Mona Vale Road East upgrade – Manor Road, Ingleside to Foley Street, Mona Vale

Addendum Review of Environmental Factors

Figure 3-2: Truck arrestor bed – proposed modification

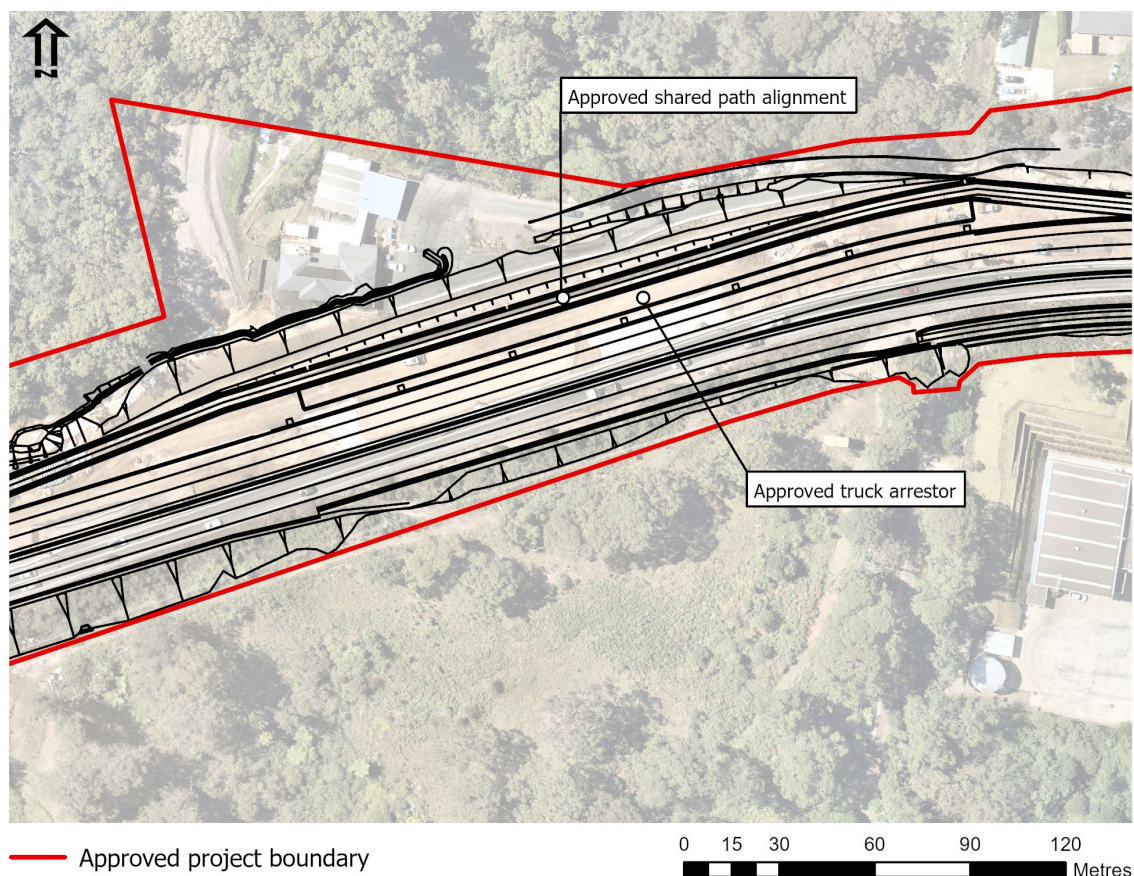
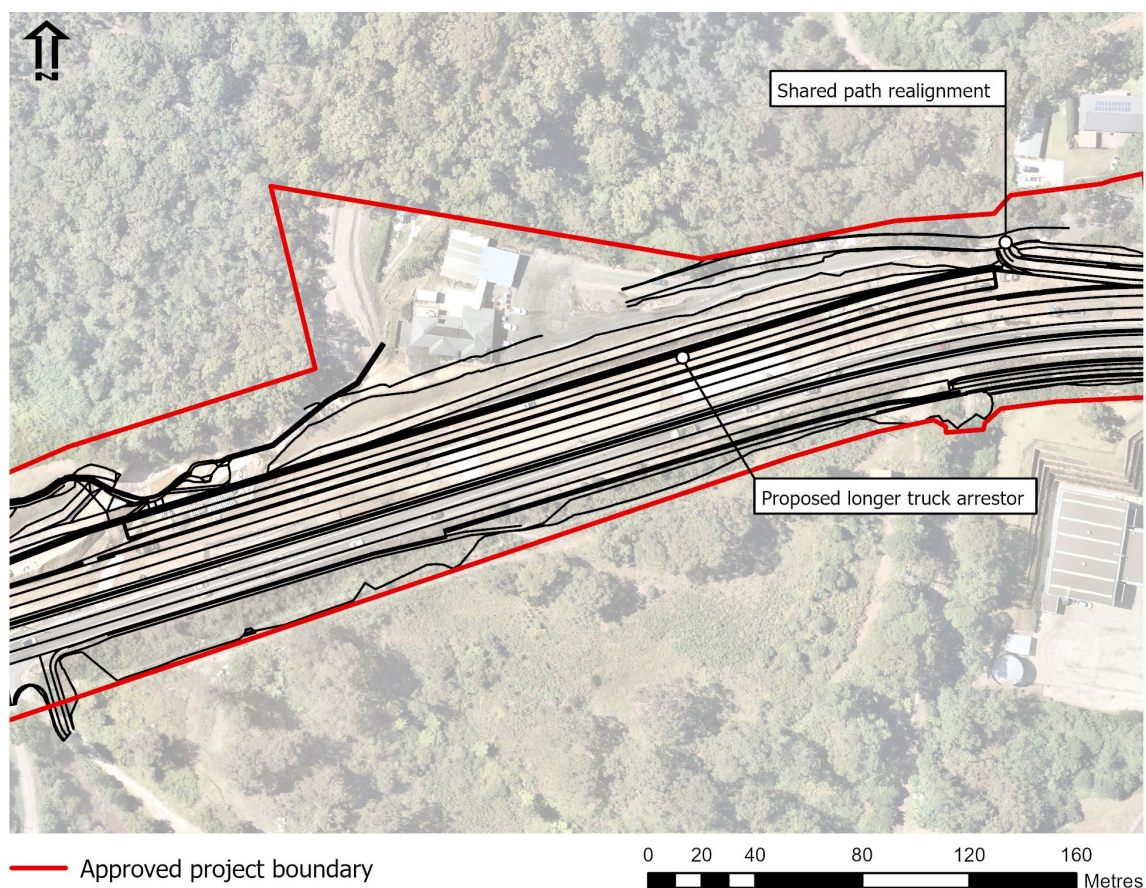
The approved proposal includes the provision of a truck arrestor bed next to the eastbound lane approaching Walana Crescent, near the bottom of the steep descent. The purpose of the arrestor bed is to provide a safe 'escape route' for heavy vehicles with braking problems. The heavy vehicle is safely decelerated and stopped by the drag caused by the vehicle as it sinks into the bed material.

Changes to the alignment of the proposed shared path have created an opportunity to further enhance safety by lengthening the truck arrestor bed by about 100 metres (to a length of about 280 metres). The approved truck arrestor bed is shown in Figure 3-1, while the proposed longer truck arrestor bed is shown in Figure 3-2. A typical cross section is provided in Figure 3-3

Figure 3-5: Shared path connection between Lane Cove Road and Walana Crescent

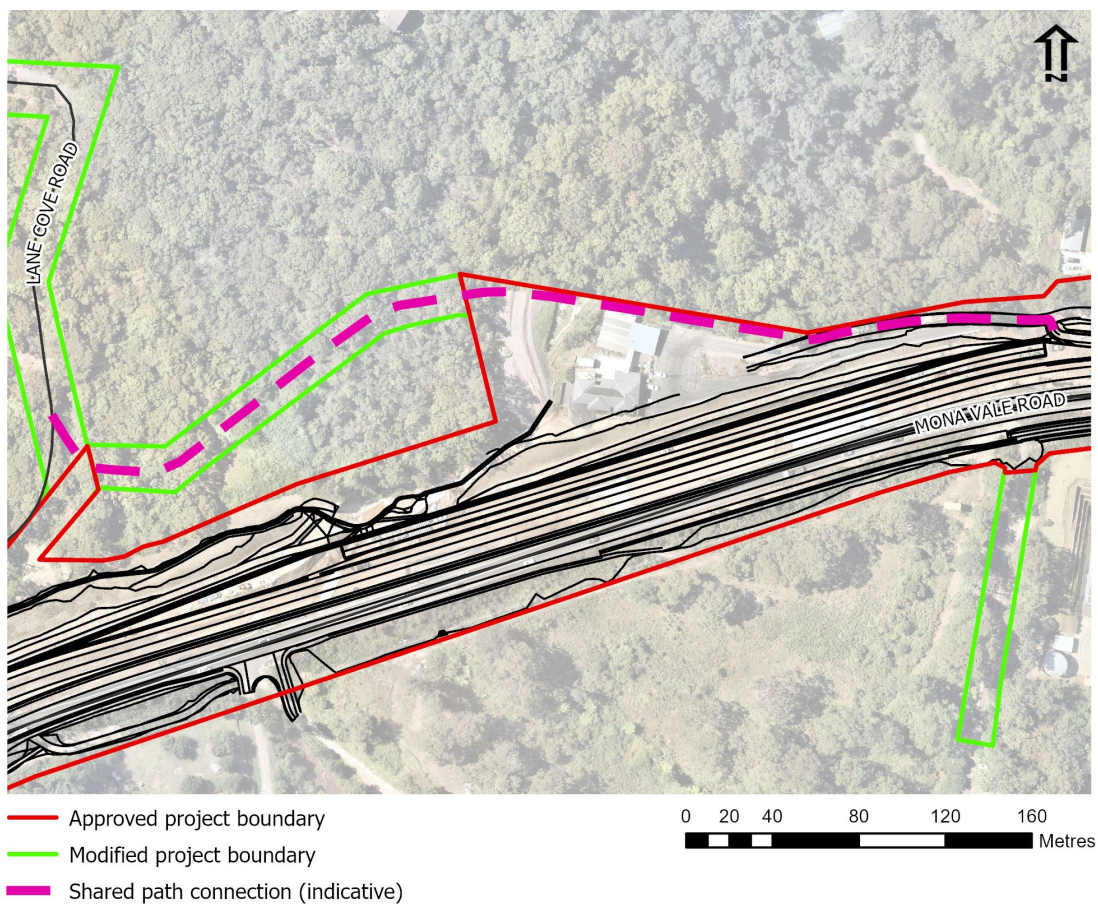
- On-road provision shared path (with separation from traffic lane) on Lane Cove Road where verges are narrow
- New variable width concrete path link between Lane Cove Road and Walana Crescent, using structures and/or switchbacks to minimise grades where feasible without the need for large vegetation losses
- Provision of new shared zone and Walana Crescent, and use of existing shared zone on Wallaby Circuit and path connection from Wallaby Circuit to Mona Vale Road
- Provision of shared path, in cooperation with Northern Beaches Council, using existing access road within the Mona Vale Cemetery. The access road pavement would be milled and resheeted and landscape planting would be provided to increase privacy of nearby grave sites.

The shared path route is shown in Figure 1-2. A typical cross section of the proposed shared path is provided in Figure 3-4, while the connection between Lane Cove Road and Walana Crescent is shown in Figure 3-5. The route via Walana Crescent and Wallaby Circuit is shown by Figure 3-6 while the route through Mona Vale Cemetery is shown in Figure 3-9.

Figure 3-12: Proposed guard rail on Lane Cove Road

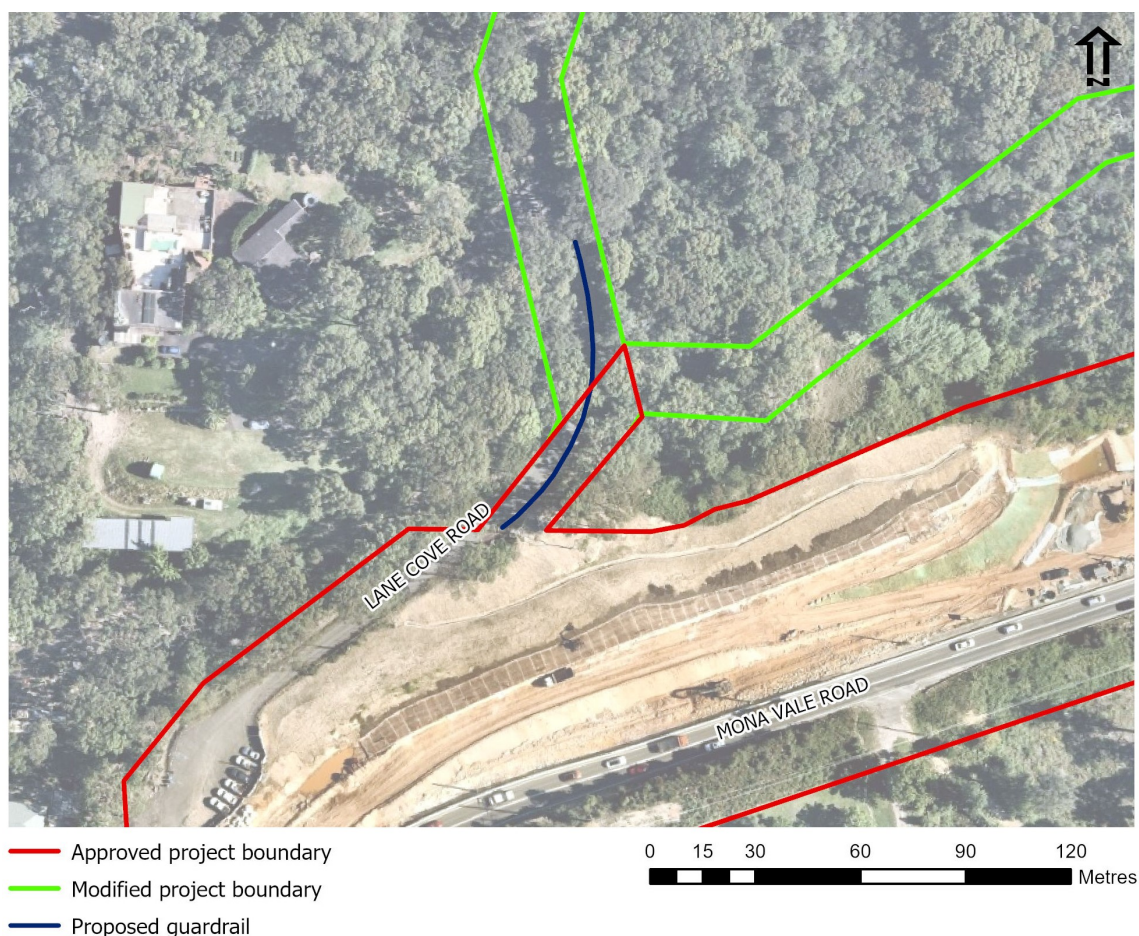
To improve safety for road users on Lane Cove Road, a new W-beam guardrail is proposed on the steep descent near the large Mona Vale Road cutting. The proposed extent and alignment of the guardrail is shown in Figure 3-12.

Figure 3-13: Proposed new permanent stormwater detention basin and associated drainage works

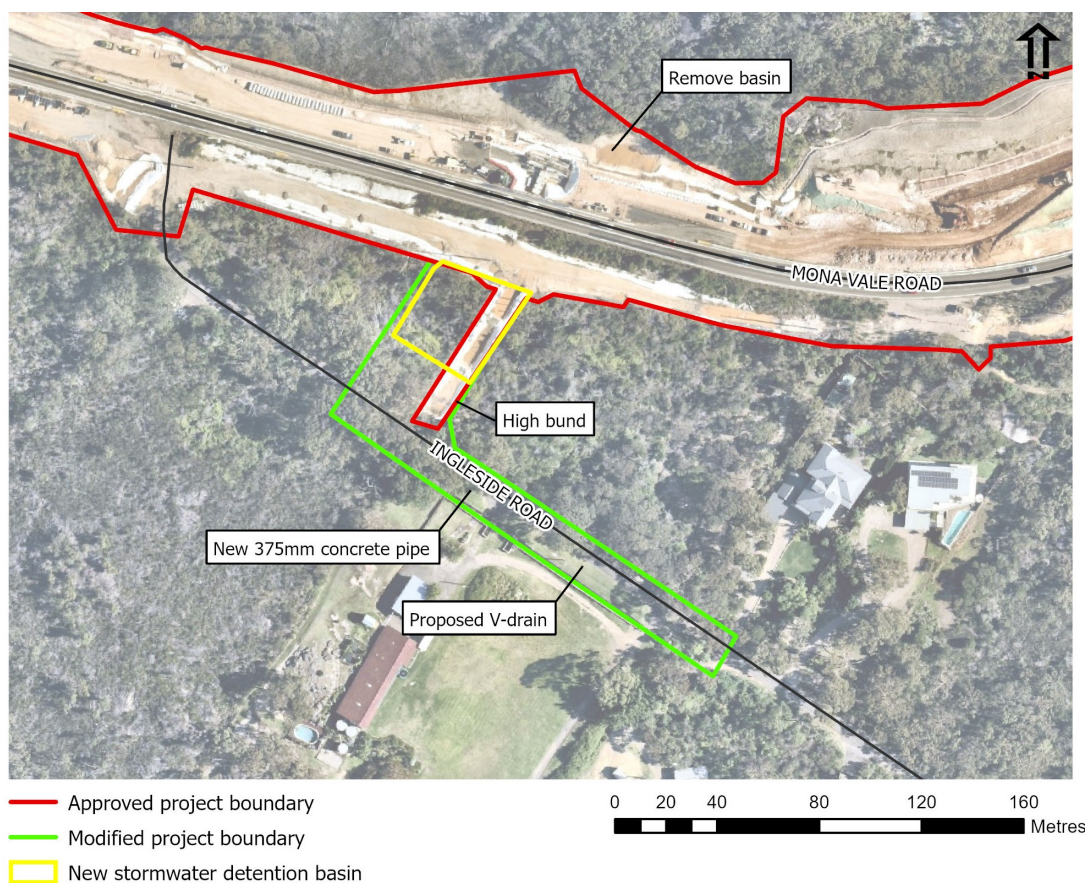
- Provision of a new permanent stormwater detention basin between the southern side of Mona Vale Road and Ingleside Road (refer to Figure 3-9). The basin would replace a previously proposed basin on the northern side of Mona Vale Road and would include a 375 millimetre concrete pipe outlet, a basin spillway and associated high bund.

- Provision of a 375 millimetre concrete pipe extending along Ingleside Road for about 110 metres (refer to Figure 3-9).
- Construction of a new 1.5 metre wide 0.25 metre deep concrete lined V-drain along Ingleside Road for about 100 metres (refer to Figure 3-9).

Figure 3-14: Proposed drainage works on Boundary Street

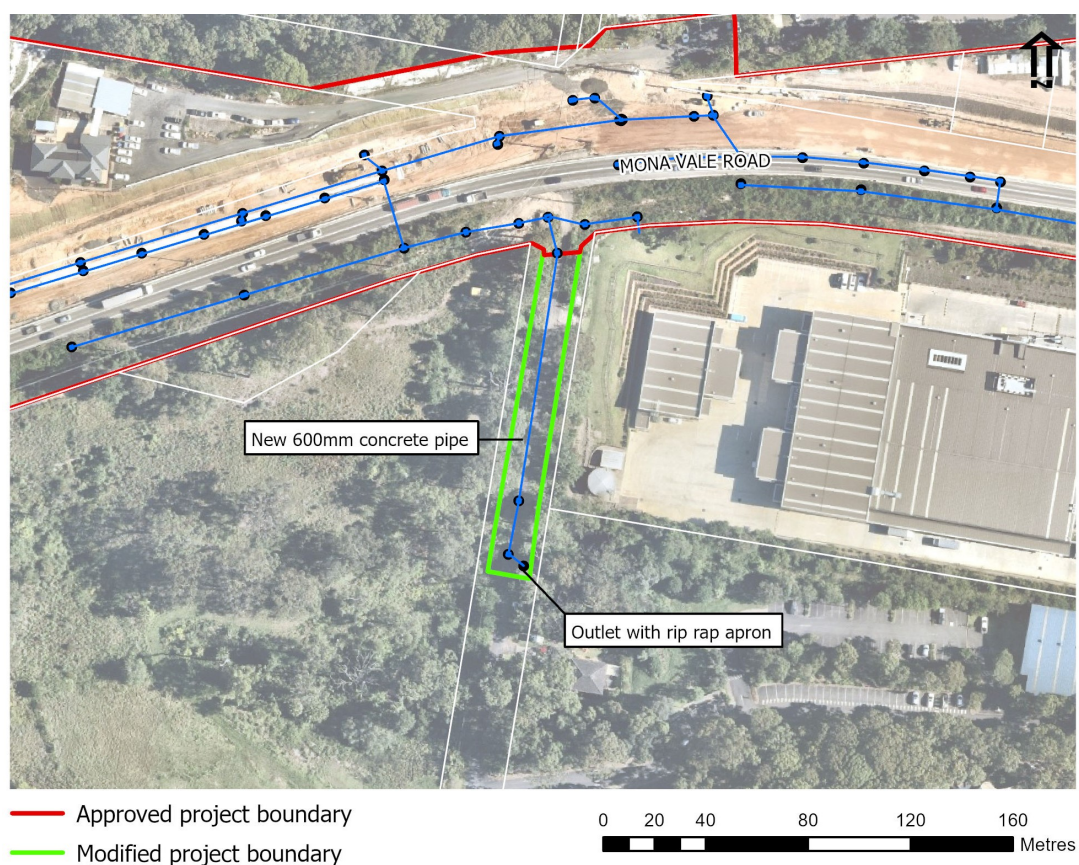
- Provision of a 600 millimetre concrete drainage pipe along Boundary Street and the construction of an associated outlet, including construction of a rip rap (rocky material) apron (refer to Figure 3-14) (no change to the drainage catchment is proposed)

Figure 3-15: Proposed utility adjustments – boundary changes

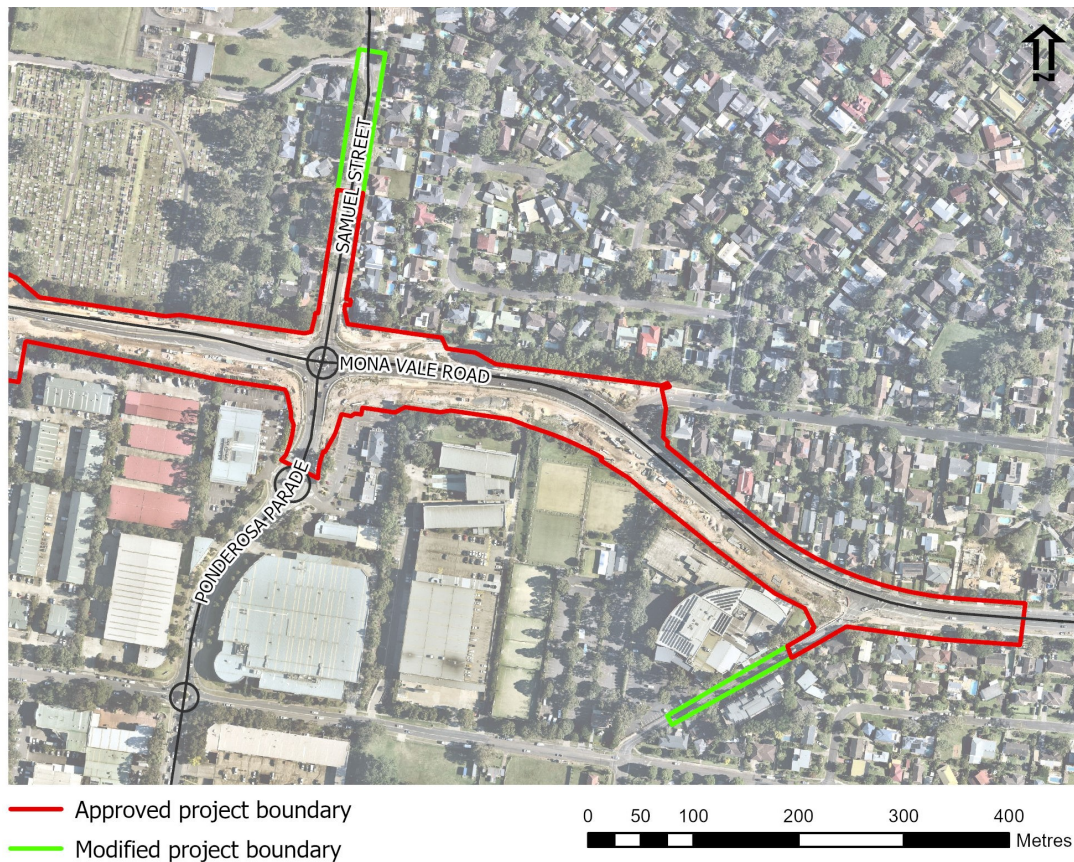
The proposed modification includes utility adjustment works (within the extent of the road pavement) on Samuel Street and Foley Street. These adjustment works require an adjustment to the approved project boundary, as shown in Figure 3-15.
